December 12, 2019

**Re: Subsurface Conditions Report Addendum - Revised
Point Wells Redevelopment
Unincorporated Snohomish County, Washington
17203-57**

In this letter, we provide additional geotechnical information to address items in Snohomish County's May 9, 2018 Supplemental Staff Recommendation document, the County's May 9, 2018 landslide hazard area memorandum (from Randolph Sleight), and the County's June 1, 2018 Findings of Fact/Conclusions of Law document for the hearing examiner. We clarify project geotechnical information provided in the Subsurface Conditions Report (Hart Crowser 2018) and provide supplemental geotechnical information for the Point Wells Redevelopment (Project) in unincorporated Snohomish County, Washington. This letter is an addendum to our April 20, 2018 Subsurface Conditions geotechnical report. Subsequent sections are organized using the general headings from the County's May 9, 2018 Staff Recommendation document.

Point Wells Richmond Beach, Washington	
Liquefaction Analysis of SPT Samples	
17203-54	06/18
	Figure 26

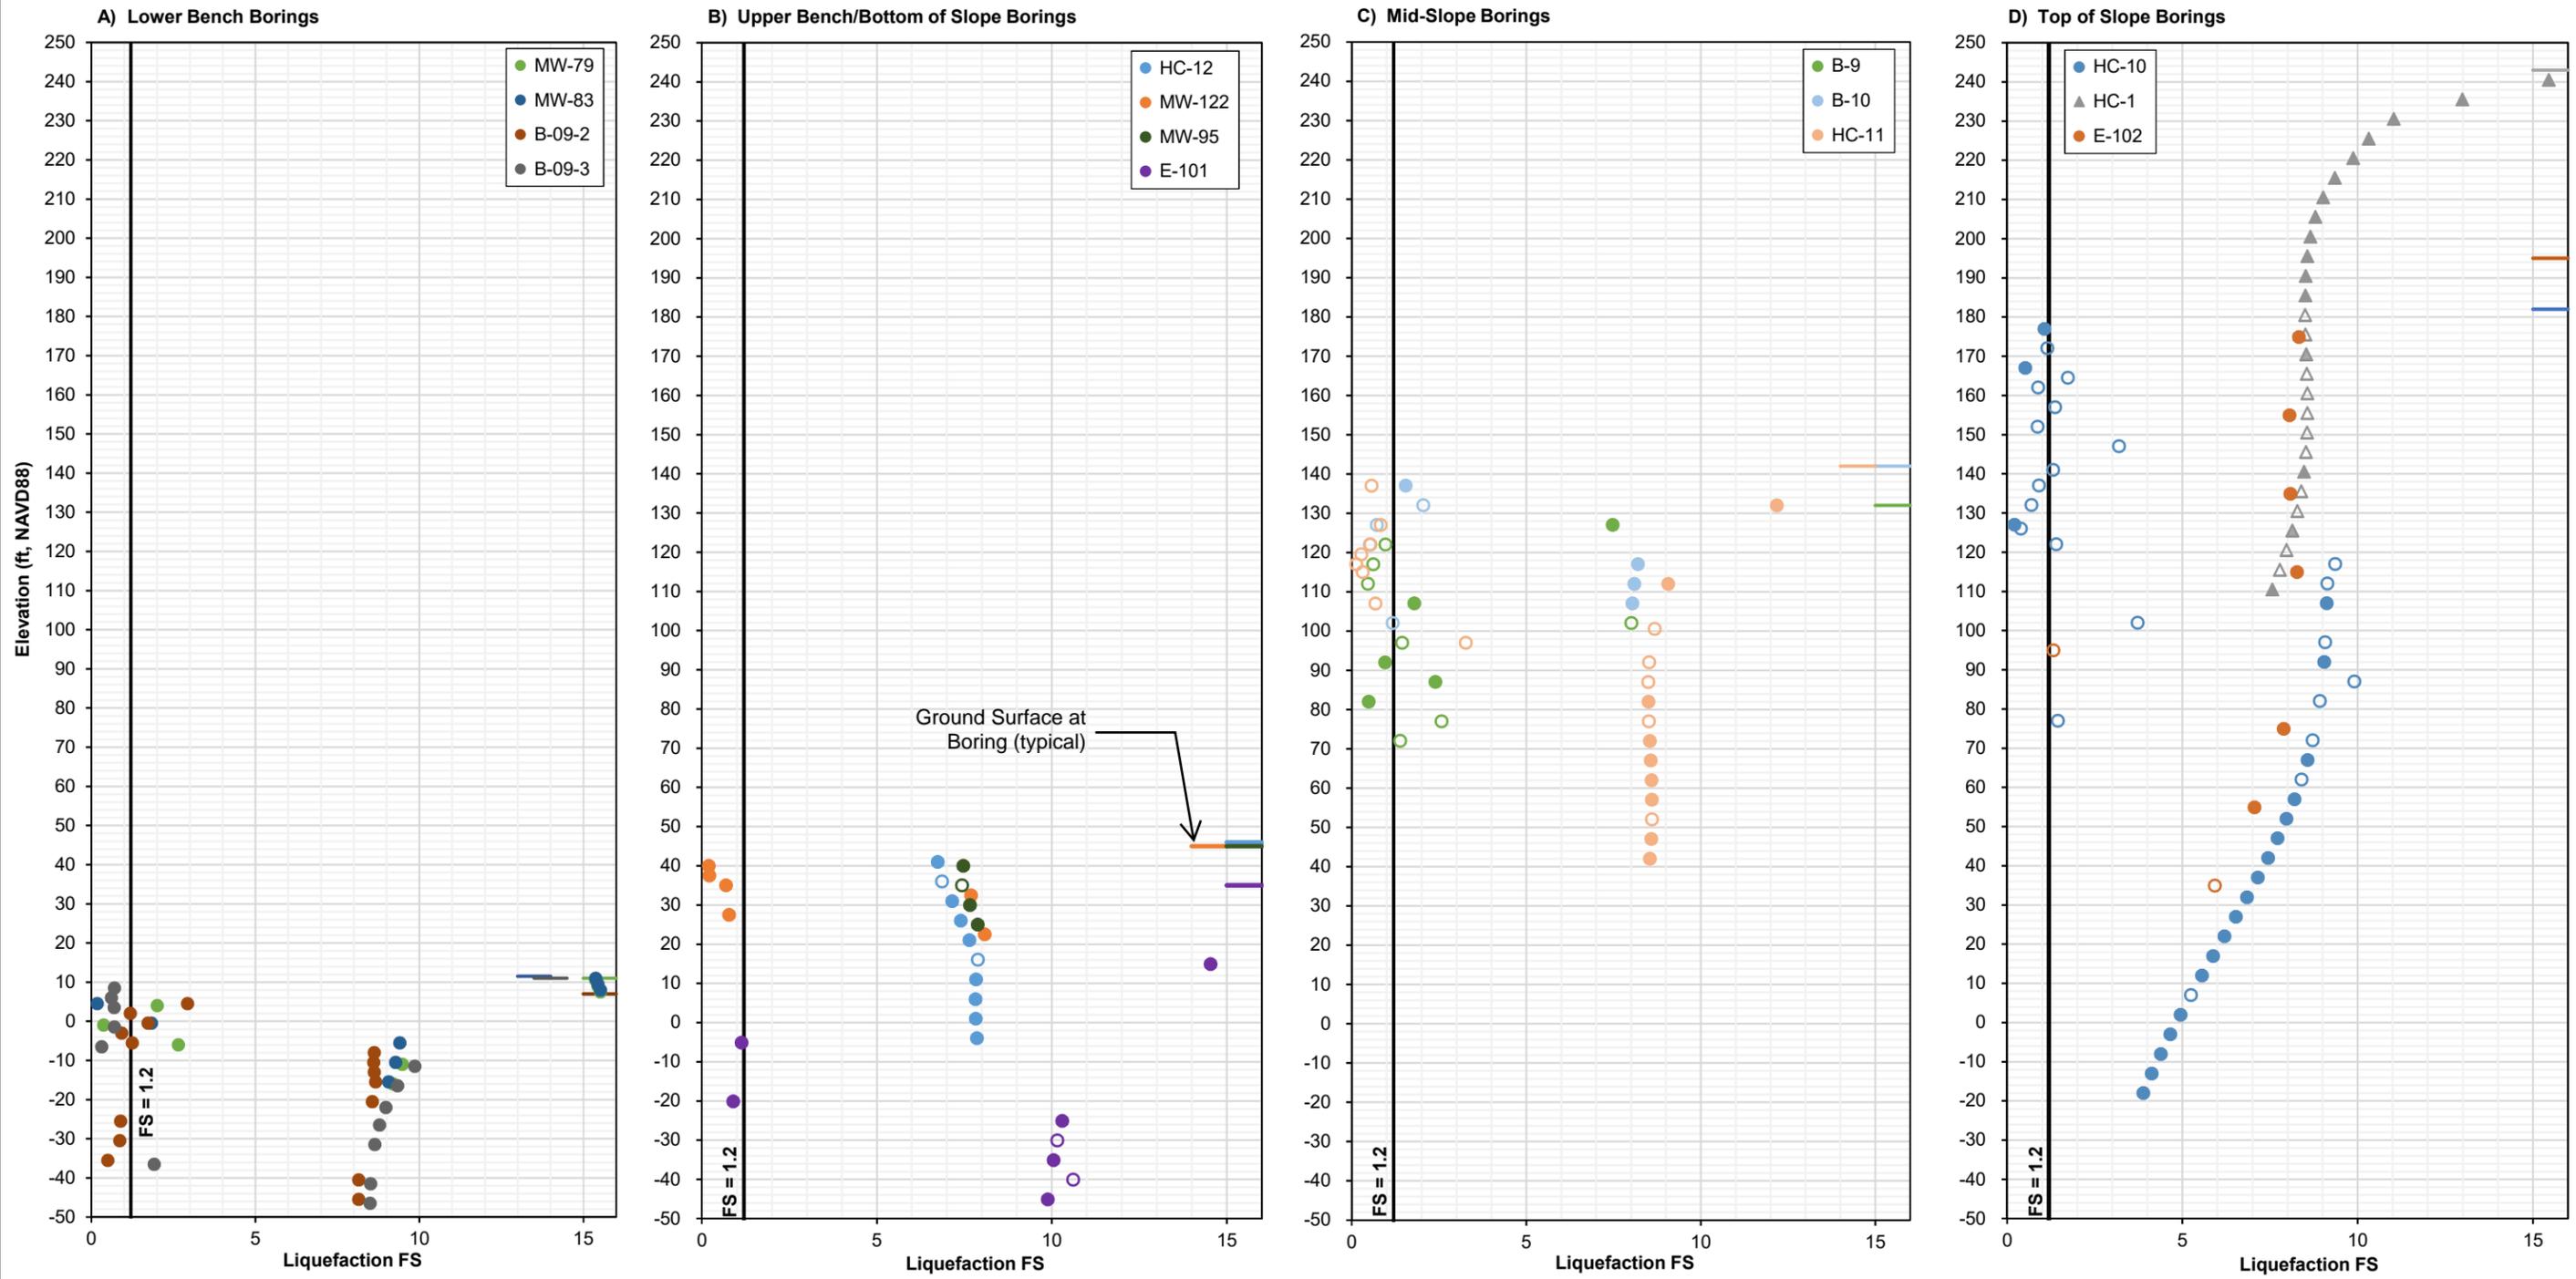
- Liquefaction susceptibility on site was evaluated using the Idriss & Boulanger (2008) method for standard penetration test (SPT) blow counts from both historical and recent borings on site (Figure 26). For fine-grained soils, liquefaction susceptibility was further evaluated using the Bray & Sancio (2006) method, based on Atterberg limits and natural water contents of exploration samples (Figure 27). Fine-grained samples of higher plasticity and lower water contents are generally not expected to liquefy, and these characteristics were determined for the majority of samples that have Atterberg limits laboratory tests. Atterberg limits and water content information was used to classify the general geologic units (i.e. Lawton Clay, Glacial Outwash, Transitional Beds, etc.) as “non-susceptible”. Figures 26 and 27 (new figures, attached) illustrate our findings on the liquefaction potential across the site: including the Lower Bench, the Upper Bench, and the East Slope.
